STATE OF CALIFORNIA - DEPARTMENT OF TRANSPORTATION
Caltrans

480 V ROADWAY LIGHTING - WB

DETAILS
TOWER AND SUSPENSION CABLE
480 V MAIN SUSPENSION CABLE LIGHTING WIRING DIAGRAM
 NO SCALE

E-236

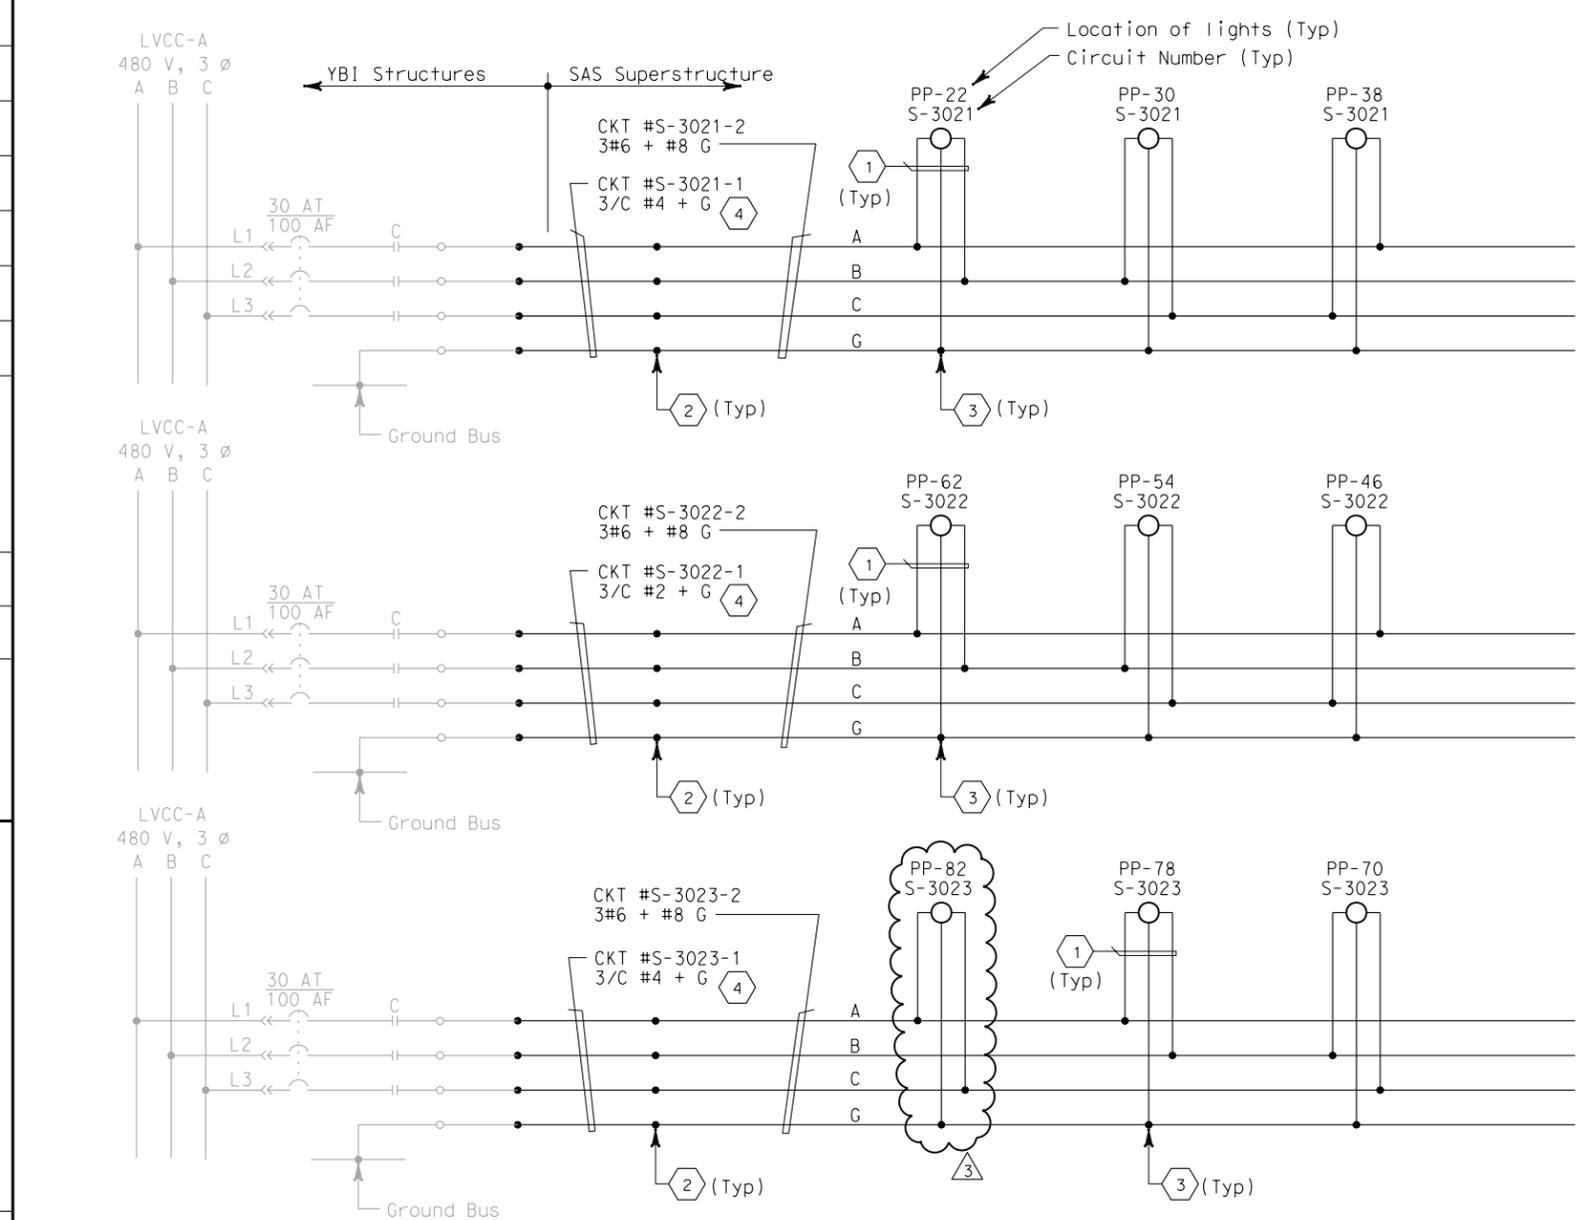
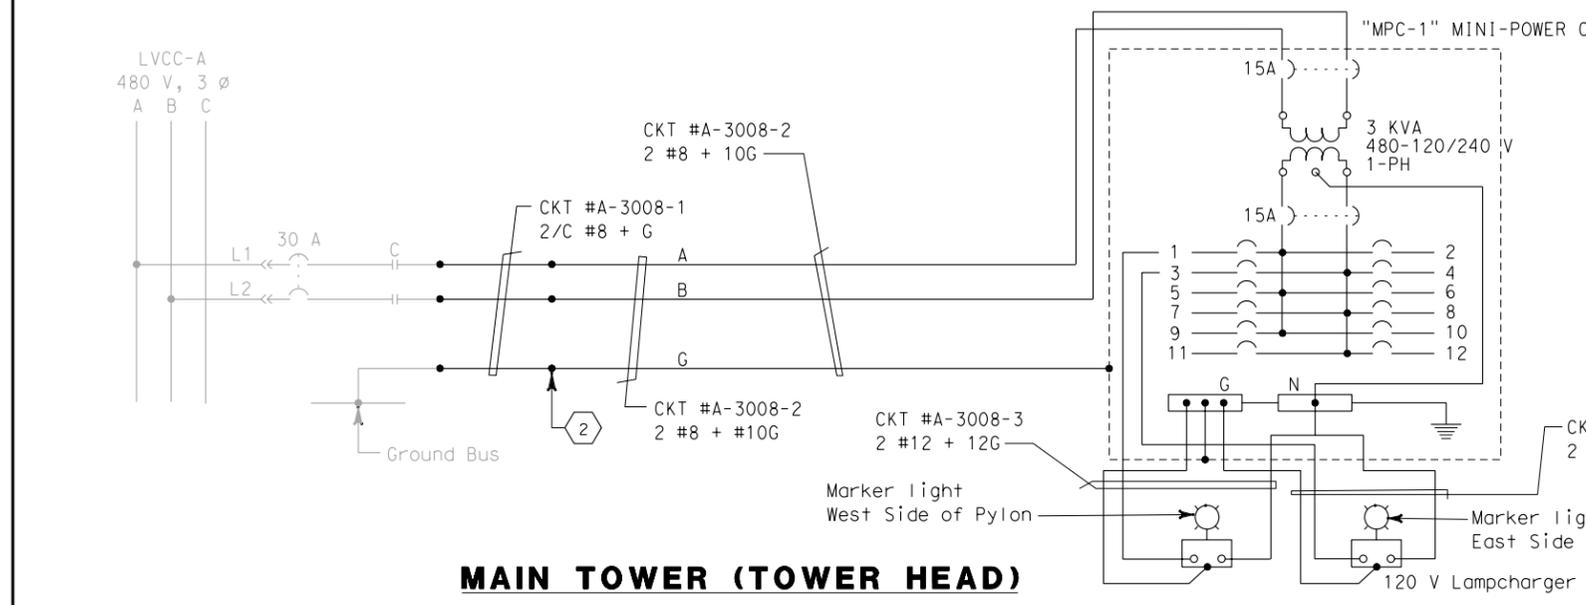
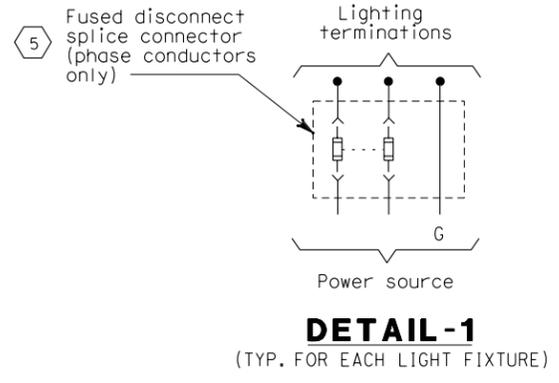
REQUEST FOR INFORMATION NOT ADDRESSED IN THIS CCO REMAIN IN FORCE						
MARK	DATE	DESCRIPTIONS	BY	CH'D	CCO#	
3	03/02/12	ADDITIONAL CABLE LEDs	RR	RG	16752	
2	10/10/08	LIGHTING REVISIONS	RY	RG	43	
1	09/24/08	CABLE ELECTRICAL	RR	RG	72

- 1 2/C #10 + G. See Detail 1.
- 2 Conductors spliced inside junction box PB-2A located inside girder.
- 3 Conductors spliced inside junction box PB-1F located suspender main cable.
- 4 The Contractor shall extend and coil 5 meters of cable in manhole 25. All cables shall be tagged with circuits numbers as shown.
- 5 Install 5A in-line fuse per light fixture, inside PB-1F.
